TRAILS END, MONUMENT DESIGN DEVELOPMENT BASE PLAN

WAY ARCHITECTS, P.C.
138 SOUTH TEALAN
COLORADO SPRINGS, COLORADO 80903
(719) 432-8800
REVISED 7/27/21

**TRAILS END, MONUMENT
DESIGN DEVELOPMENT
BASE PLAN**
OLD DENVER HIGHWAY
MONUMENT, COLORADO 80132

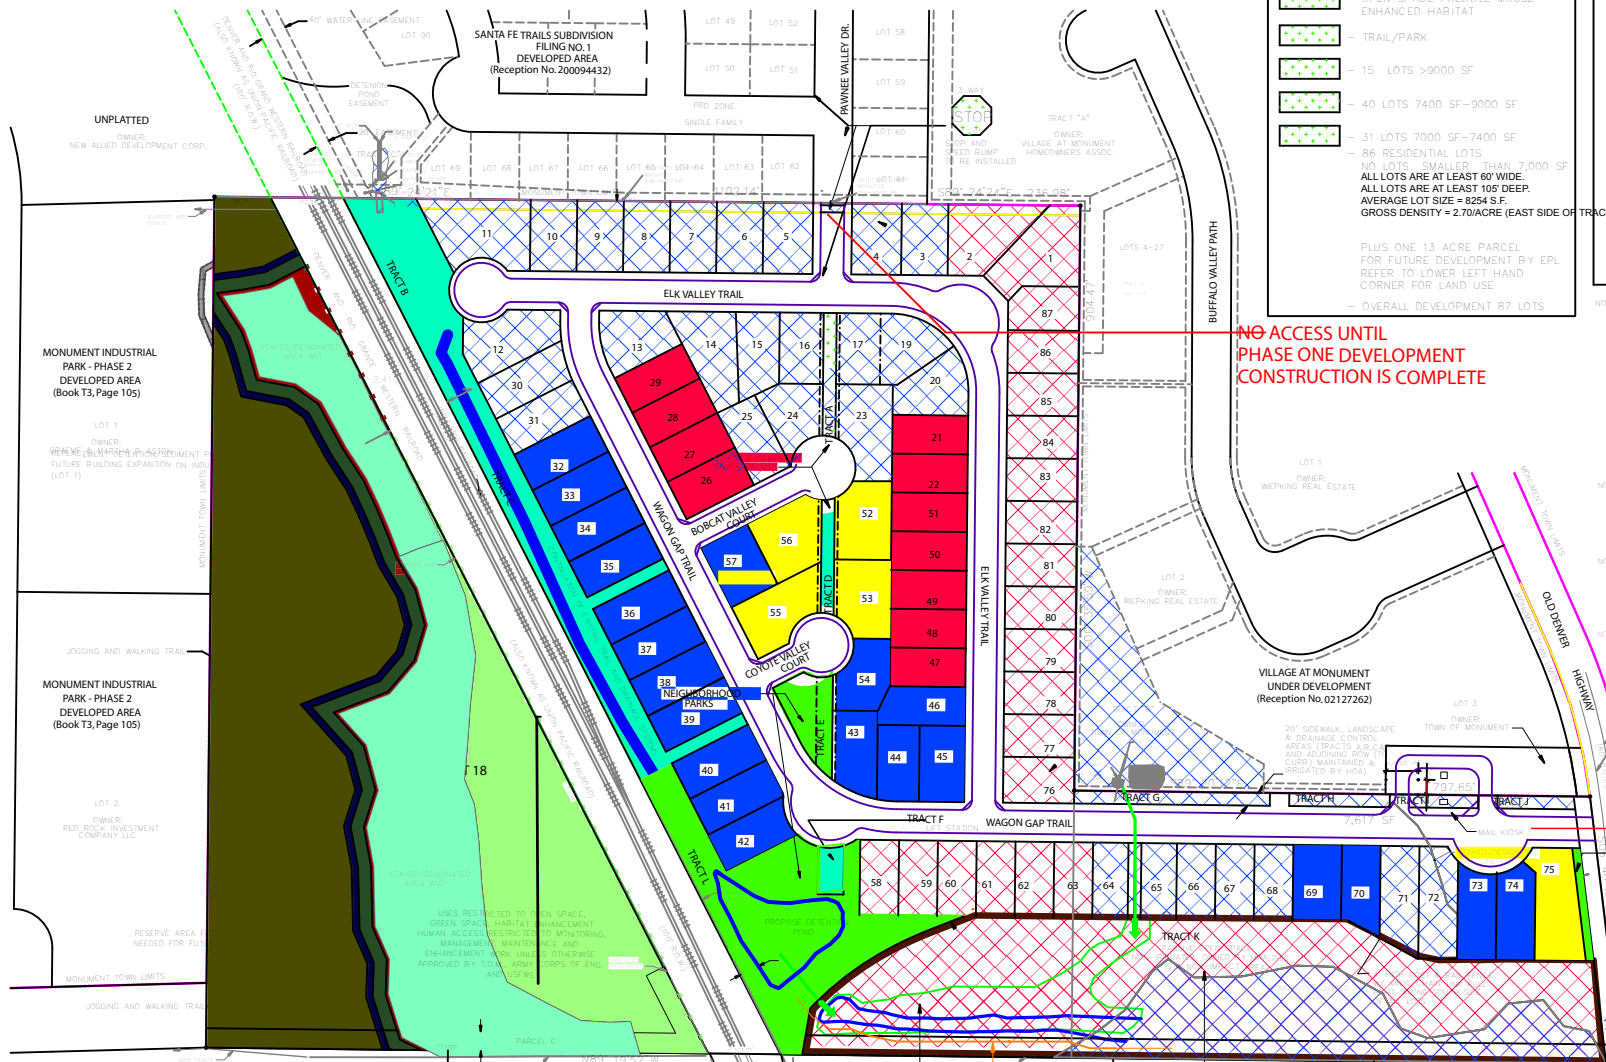
- NOTE 1: THE REVISION ADDING LOT 18 HAS BEEN PROPOSED TO FACILITATE A MORE APPROPRIATE FORM OF DEVELOPMENT AND A RESOLUTION TO REGULATORY CONCERNS FOR THE 13 ACRES WEST OF THE RAILROAD TRACKS. THROUGH RECORDATION OWNERSHIP AND RESPONSIBILITY WILL BE ESTABLISHED TO PROVIDE LONG-TERM MAINTENANCE FOR THE JURISDICTIONAL WETLANDS. THE REVISIONS DEMONSTRATED HEREIN, AS WELL AS ACCOMPANYING LAND-USE CONDITIONS ARE SUBJECT TO TOWN OF MONUMENT AND ARMY CORPS OF ENGINEERS ADMINISTRATIVE APPROVAL AND REVIEW BY USFWS.

- NOTE 2: REQUESTS FOR APPROVALS FOR LOT 18 ARE LIMITED TO PLATTING AND PUD OPEN SPACE ZONING AND "SPEAKER USES". ANY FUTURE DEVELOPMENT IS SUBJECT TO REVIEW AND APPROVAL OF PREVIOUSLY MENTIONED AGENCIES.

- NOTE 3: ALL TERM SUBMITTAL PLANS AND DOCUMENTS ARE TO BE REVISED PRIOR TO BOARD OF TRUSTEES REVIEW AND RECORDATION IF THE PROPOSER CHANGES HEREIN ARE ACCEPTED BY TOWN OF MONUMENT ADMINISTRATION AND PLANNING COMMISSION.

- NOTE 4: USFWS MAY REQUIRE DEED RESTRICTIONS TO COVER SPECIAL AREAS AND CONVEYORS OF DEVELOPMENT.

- JURISDICTIONAL WETLANDS (APPROX. 3.7 AC.)
- UPLAND RESERVE AREA (APPROX. 2.46 AC.)
- DEVELOPABLE AREA, LIMITED TO HARD SURFACE PARKING, ACTIVE & PASSIVE RECREATIONAL FACILITIES & DETENTION & DRAINAGE FACILITIES FOR EXPANDED DEVELOPMENT OF ADJACENT INDUSTRIAL AREA (APPROX. 5.55 AC.)
- 10' LANDSCAPING/DRAINAGE SWALE FOR SEDIMENT CONTROL
- 20' TRANSITION AREA TO ALLOW FOR 10' FILL @ 2:1 SLOPE MINIMUM 5' SETBACK FOR TOE OF FILL SLOPES
- UNPLATTED
